MCF5282 Reference Manual Errata

This errata document describes corrections to the *MCF5282 ColdFire Microcontroller Reference Manual*, order number MCF5282UM. For convenience, the addenda items are grouped by revision. Please check our website at <http://www.freescale.com> for the latest updates.

MCF5282UMAD
Rev. 7
11/2004

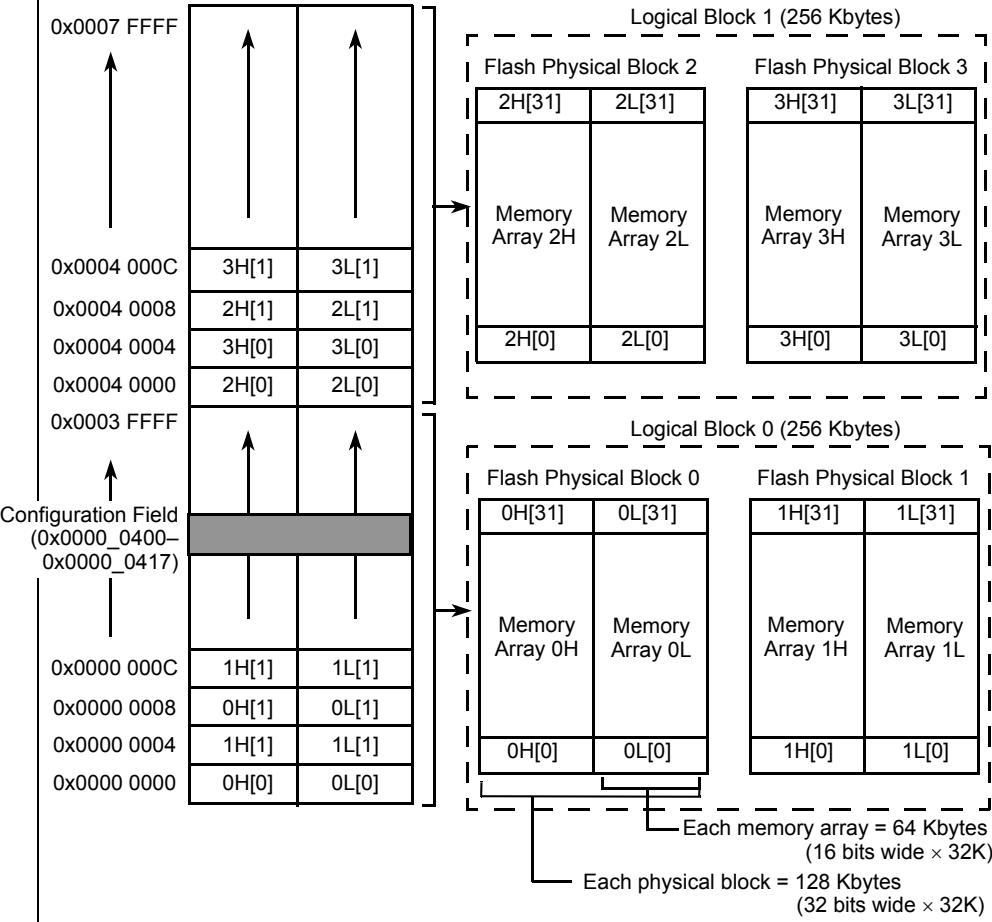
Location	Description
Figure 6-2/6-4	<p>Replace Figure 6-2, "CFM 512K Array Memory Map," with the figure below.</p>  <p>Figure 6-2. CFM 512K Array Memory Map</p>
Table 6-12/6-16	Change value for page erase verify command to 0x06.
Table 6-13/6-20	Change value for page erase verify command to 0x06.
Table 8-3/8-5	Add the following note to the BDE bit description: "The SPV bit in the CPU's RAMBAR must also be set to allow dual port access to the SRAM. For more information, see Section 5.3.1, 'SRAM Base Address Register (RAMBAR)'."
Figure 9-1/9-3	Remove $\div 2$ from CLKGEN block.

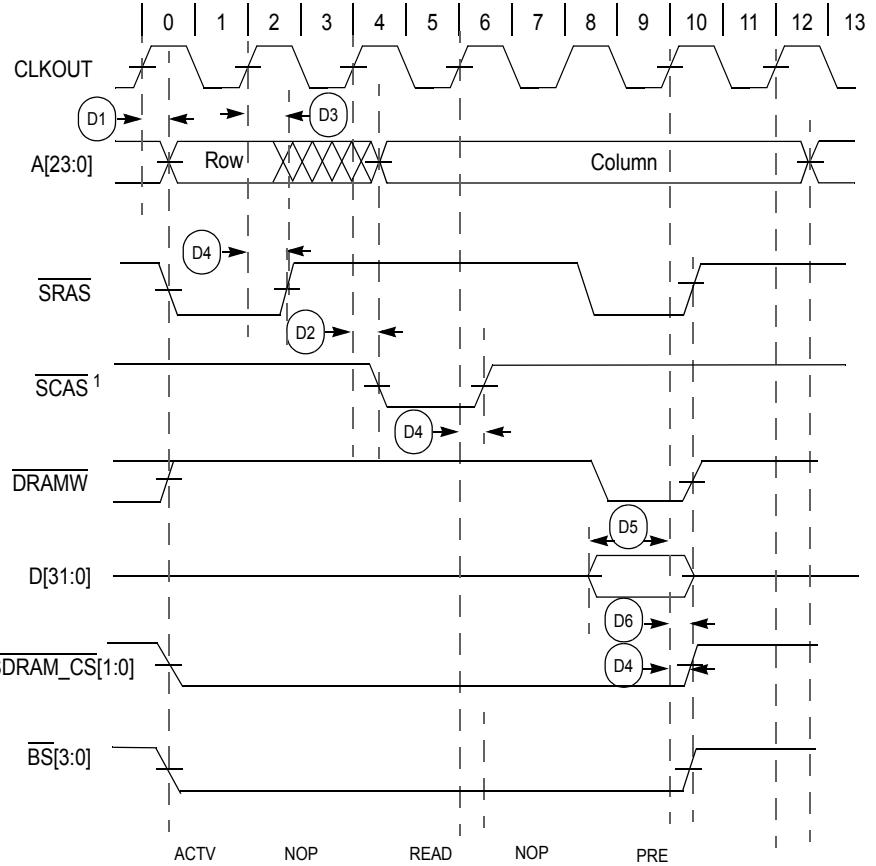
Location	Description
Figure 33-5/33-16	<p>Replace Figure 33-5, 'SDRAM Read Cycle' with the figure below.</p>  <p>The diagram illustrates the SDRAM Read Cycle timing. It shows the following signals over 14 clock cycles (labeled 0 to 13):</p> <ul style="list-style-type: none"> CLKOUT: The system clock signal. A[23:0]: Address bus, divided into Row and Column sections. SRAS: Synchronous Row Address Strobe. SCAS¹: Synchronous Column Address Strobe. DRAMW: DRAM Write enable. D[31:0]: Data bus. SDRAM_CS[1:0]: SDRAM Chip Select. BS[3:0]: Bank Selection. <p>Key events marked in the timeline:</p> <ul style="list-style-type: none"> ACTV: Active phase (SRAS goes low). NOP: No Operation (SCAS goes high). READ: Read phase (SCAS goes low). NOP: No Operation (SCAS goes high). PRE: Precharge phase (DRAMW goes high). <p>Annotations with circled D's indicate specific timing points or edge conditions for each signal across the 14 cycles.</p> <p>¹ DACR[CASL] = 2</p> <p style="text-align: center;">Figure 33-5. SDRAM Read Cycle</p>
